TECHNICAL ISSUES OF JAPANESE SEISMIC EVALUATIONS FROM THE POINT OF GLOBAL AND JAPANESE STANDARDS

Written by: Satoshi Sato (Nuclear Consultant)

This technical report reviews the methodology used by the Nuclear Regulation Authority (NRA) in assessing the seismic risks for nuclear power plants in Japan. It also assesses the approach used by Kyushu Electric Power Company in its seismic assessment for its two Pressurized Water Reactors (PWRs) at the Sendai power plant.

第 7.5.6.60 図 基準地震動の応答スペクトル及び解放基盤表面における地震動の一様ハザードスペクトル (水平方向)

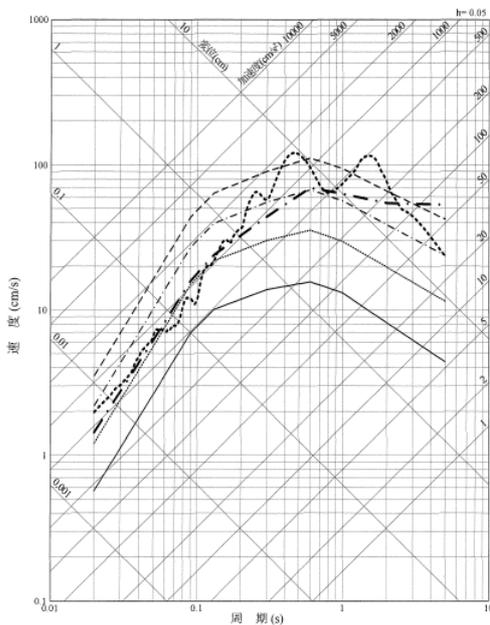
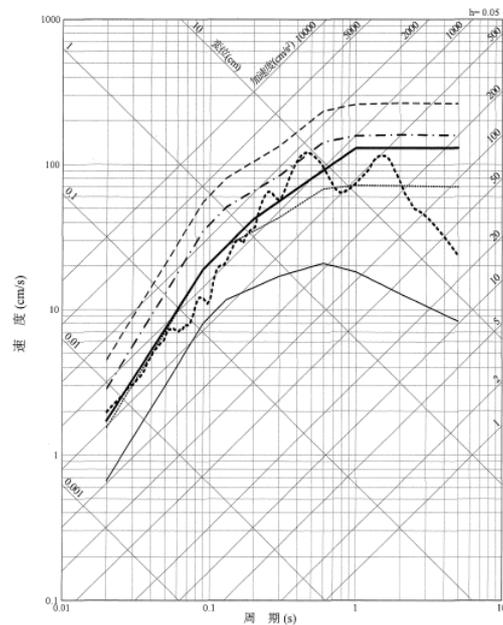
- The JNES spectra is lower than the one for the center and eastern United States for the same AEP. The credibility of JNES spectra is questionable.
- The Uniform Hazard Spectra for the hard rock and for the free-field ground surface are presented below on the left and right respectively. However, the same Ss-2 response spectrum is apparently used for both for comparison. Because of their technical implication, this is to be treated as more than a simple editorial error.

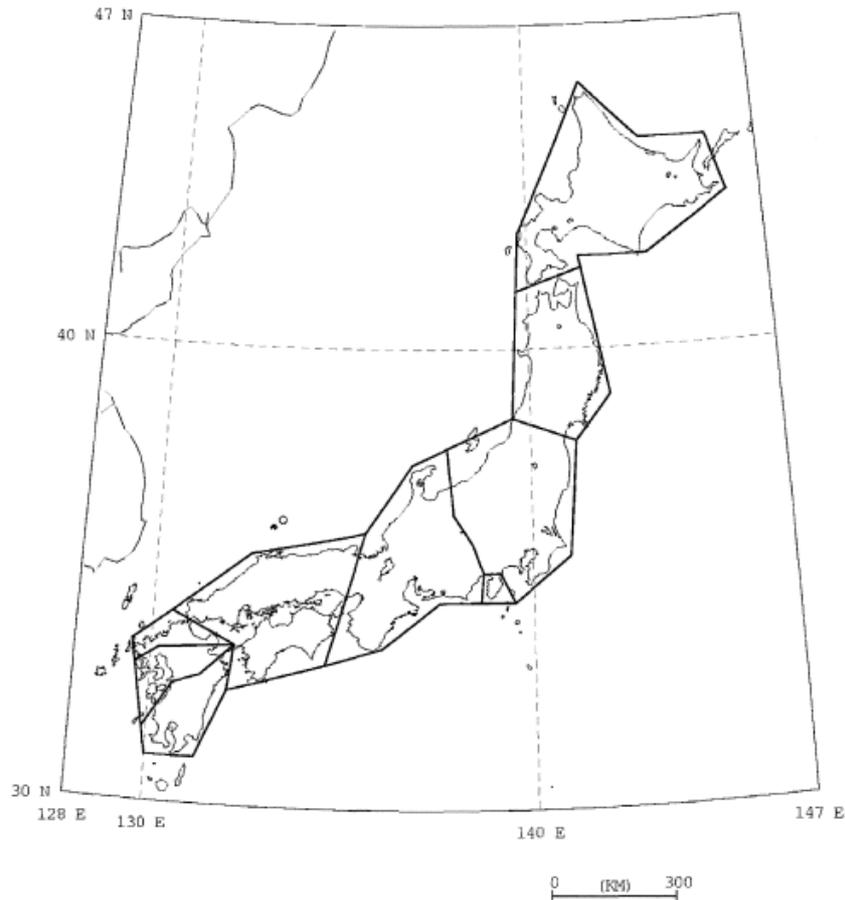
(4) The land territory of Japan is divided into eight regions in a very rough manner by the JNES (2005). Such a region map suggests that all four sites of Fukushima Daiichi, Fukushima Daini, Tokai, and Kashiwazaki-Kariwa belong to the same region, and all sites of Hamaoka, Shika, and the sites along Wakasa-Bay belong to the other same region. It does not seem to be reasonable to apply a single set of uniform hazard spectra to each of such vast regions. Nevertheless, there is no objective evidence in the safety evaluation report to support that the NRA has thoroughly assessed the adequacy of this map.

- JNES divided the entire land territory of Japan into 8 regions. The Seismic Study Commission in 2009 did it quite differently. This brings up a question. What sectioning was used by AESJ when they developed the methodology for the Uniform Hazard Spectra? Are they the same or different each other?
- The NUREG-2115 includes maps of the seismotectonics zones. Detail technical discussions are also presented in the report. No similar information is publicly available to understand the technical basis for JNES' sectioning. It is not clear even whether it represents the seismotectonics zones.

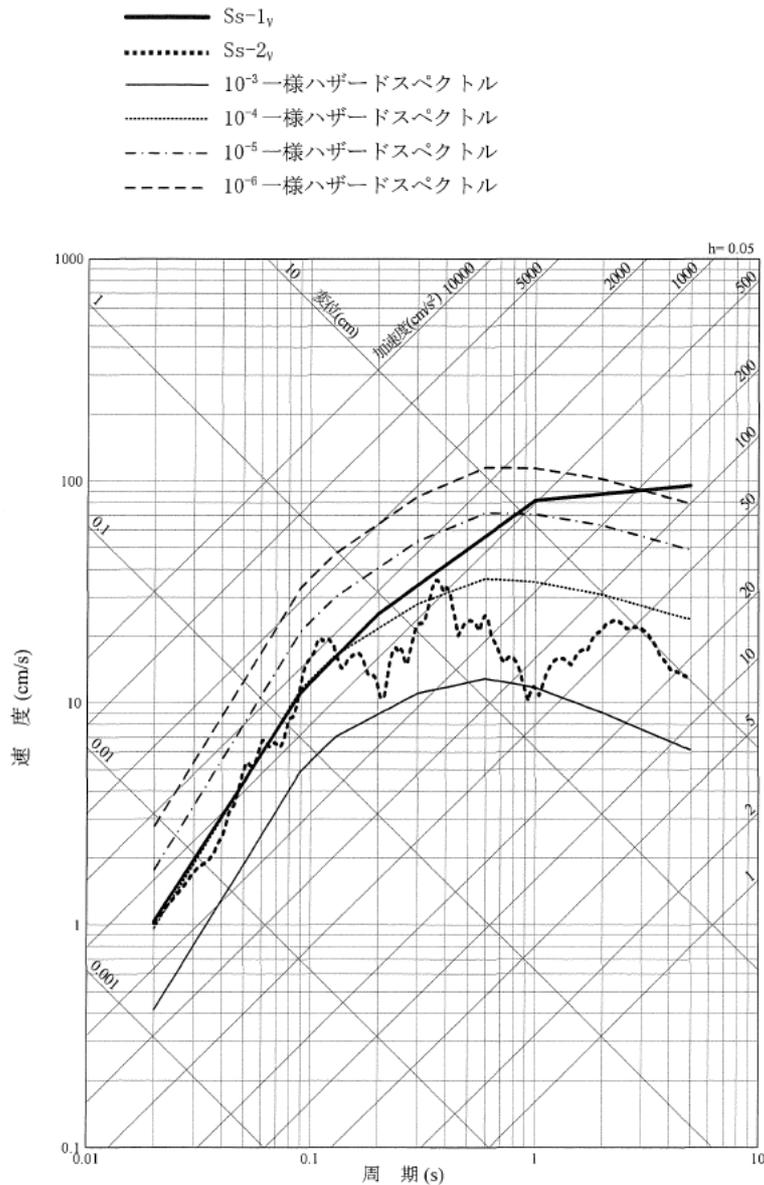
(5) By comparison with those hazard spectra mentioned above, the Kyushu Electric Power Company has derived an overall conclusion that the annual exceedance probability of their design-basis-earthquake is somewhere between $1E-4$ and $1E-6$ or between $1E-4$ and $1E-5$. However, those figures referenced in the text actually do not fully support such a conclusion statement. For example, the Ss-2 (vertical) spectrum indicates the annual exceedance probability being between $1E-3$ and $1E-4$ with some portion even greater than $1E-3$. The NRA obviously failed to point out this error.

- The attached figure does not support the statement in text in that one of the free-field ground surface response spectra (Ss-2 vertical) is completely out of the range between $1E-6$ and $1E-4$. The Ss-2 spectrum was determined without smoothening.

第2-1図 原子炉格納施設の地震応答解析モデル(水平方向)

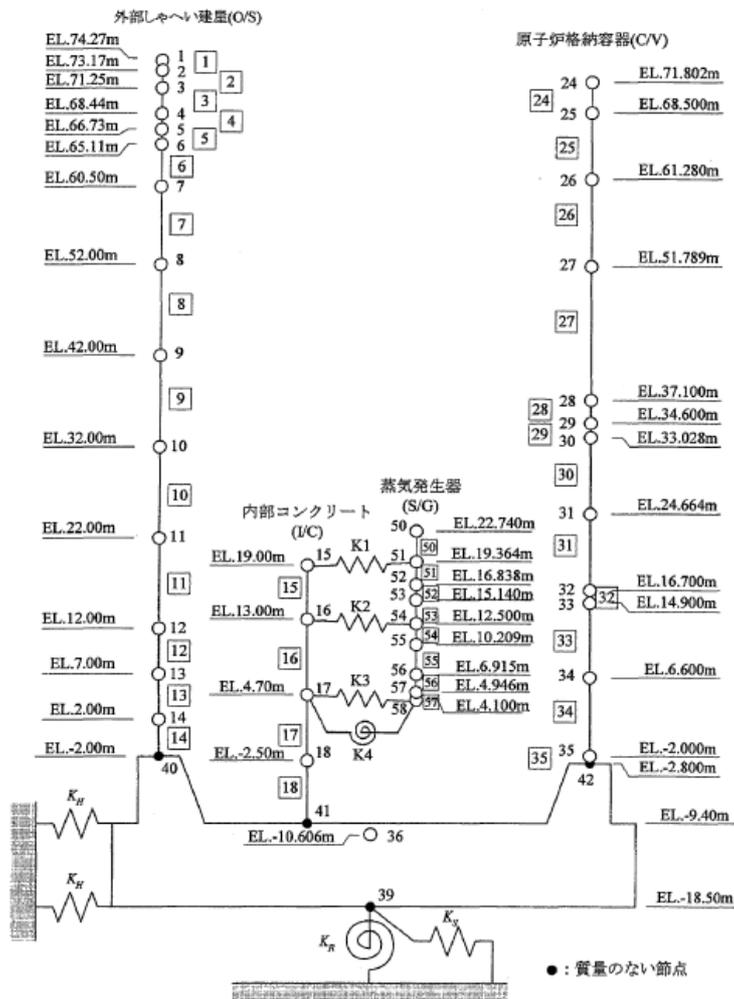
- In the sketch below, K_H and K_y represent the horizontal springs and K_R represents the rotational spring. However, no value is given to these parameters. How was NRA able to review the adequacy of Soil-Structure Interface (SSI) evaluation done

by Kyushu Electric Power Company?

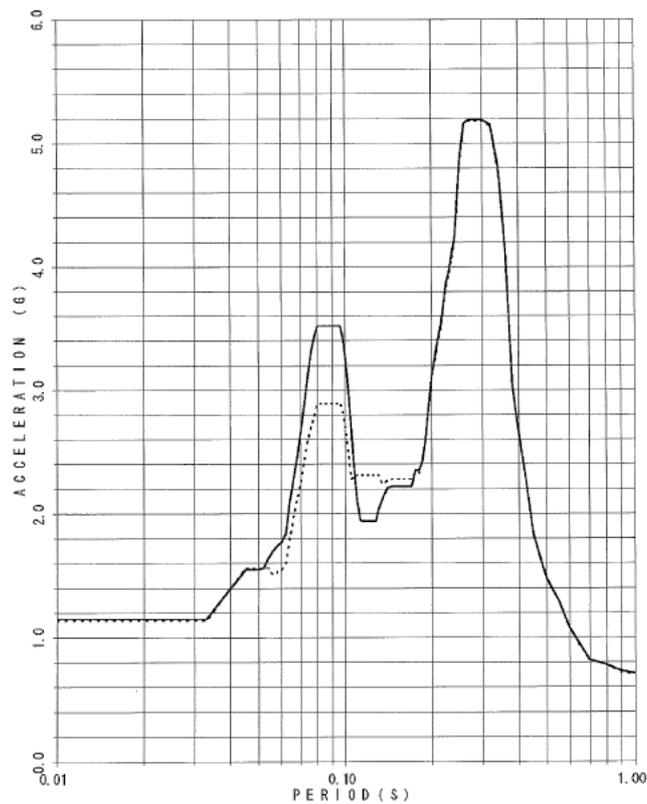
- In case of Sendai, the frequency range for analysis is cut off at 1 Hz, disabling to find the potential peaks below 1 Hz.

- The phenomenon potentially overlooked due to this practice is the resonance between building frequency and sloshing frequency. As indicated in the table below, sloshing frequency is significantly below 1Hz.
- To determine whether or not a massive sloshing flood is possible in case of Sendai,

a sensitivity analysis for the SSI effect should be performed for the frequency range including below 1 Hz.
